REMARKS

Attorney Docket No.: **LINDE-581**

Date: August 19, 2005

FIG. 1

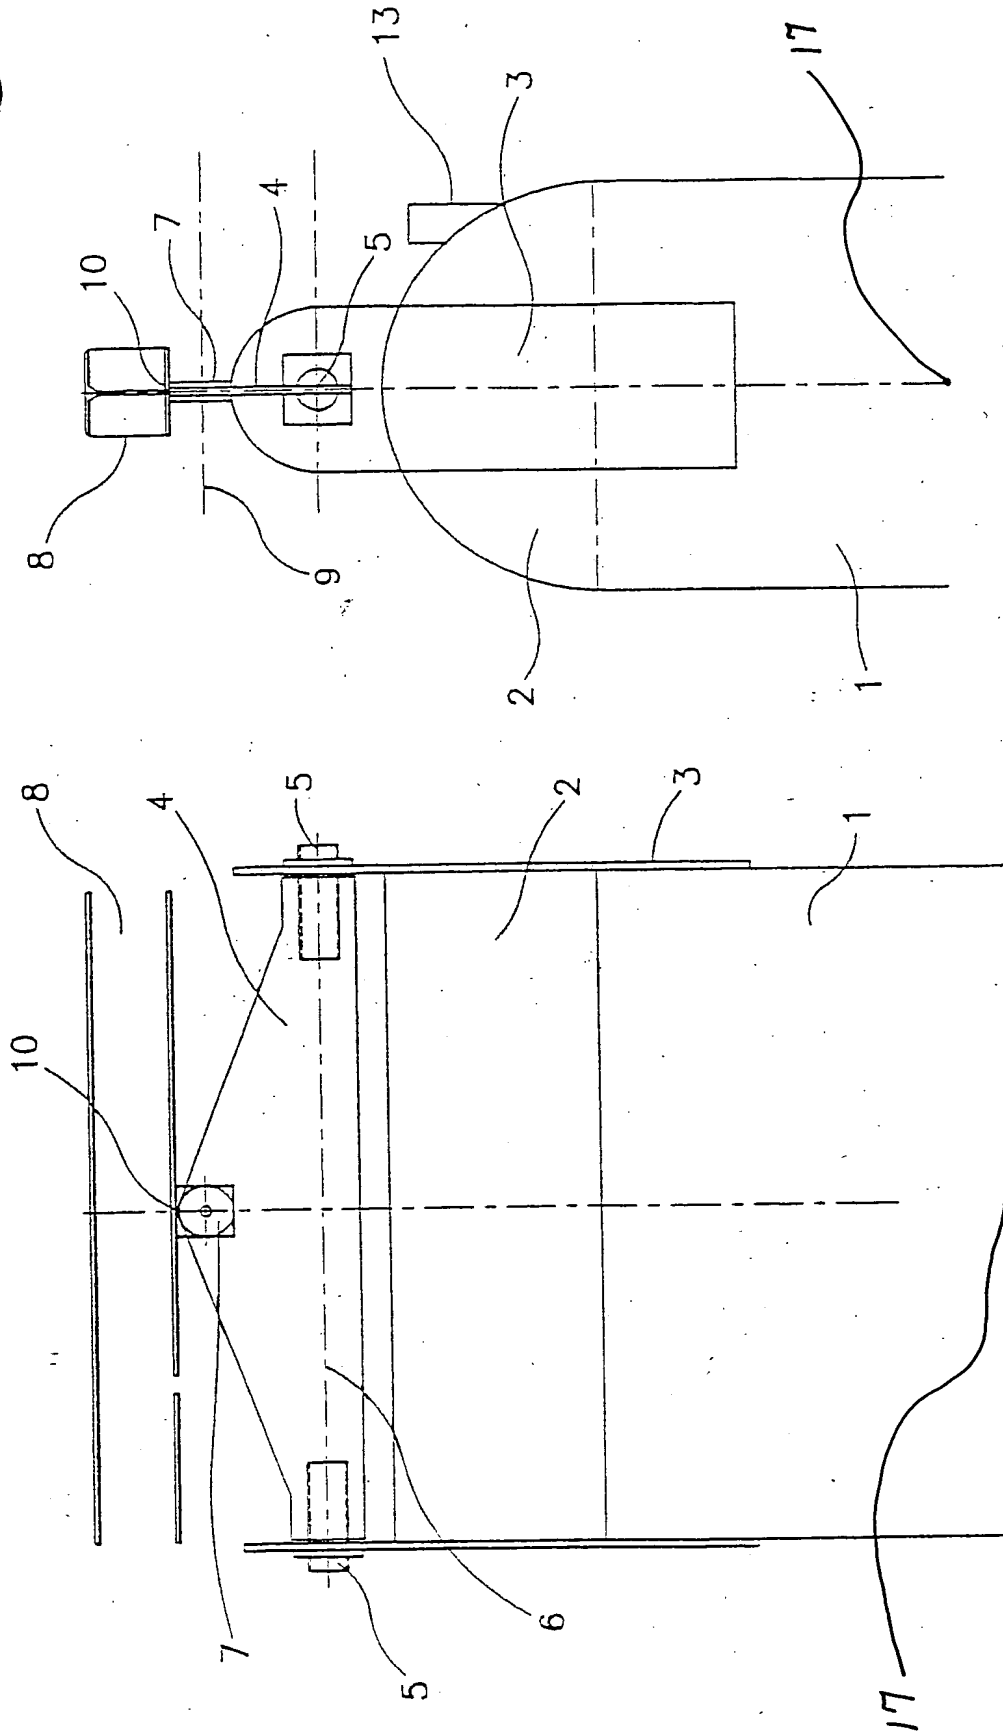
As noted above, attached herewith are Replacement Drawings showing Figures 1 and 2 in which the center of gravity 17 is explicitly shown. However, applicants respectfully submit that this change to the drawings is unnecessary. The center of gravity is an inherent feature of any object having mass. One of ordinary skill in the art would readily recognize that the heat exchange block illustrated in the figures would have a center of gravity. Since one of ordinary skill in the art can readily recognize that the object inherently has a center of gravity, it is unnecessary to illustrate this concept.

Figures 1 and 2 are amended to show the center of gravity of the heat exchange block, i.e., reference number 17. The specification is amended to provide express reference to reference number 17. The Abstract is amended to delete the term “means” in accordance with the Examiner’s request.
